Illinois Resource Adequacy Mitigation Study and Integrated Resource Plan

Workshop #2: Candidate Resources

Clean Grid Alliance Response to Request for Feedback

Cost Forecasts for Energy Storage and Gas Resources

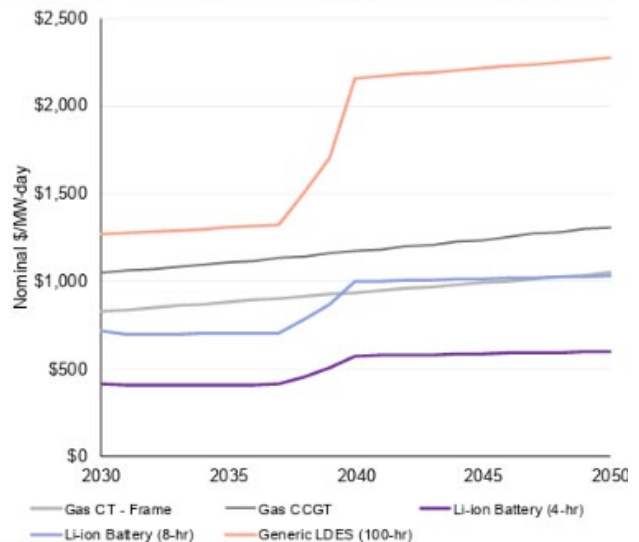
- **Levelized Fixed Costs (LFC).** Regarding the use of levelized fixed costs (LFC) for storage resources, CGA disagrees with the projected rise in LFC for all storage resources, as cost projections for utility-scale BESS projects are widely expected to drop over the coming decades, as discussed in NREL’s Cost Projections for Utility-Scale Battery Storage: 2025 Update.⁹ Beyond the expected increase in LFC due to the phaseout of federal tax credits, we would like additional explanation from the modeling team to explain the expected rise in LFC.

Cost escalation for LDES and other storage options at 2035-2040 requires clarification. CGA assumes that this escalation pertains to the expiration of federal tax incentives for these technologies. However, we are unclear as to why the increase is significantly more dramatic as to LDES over other storage technologies.
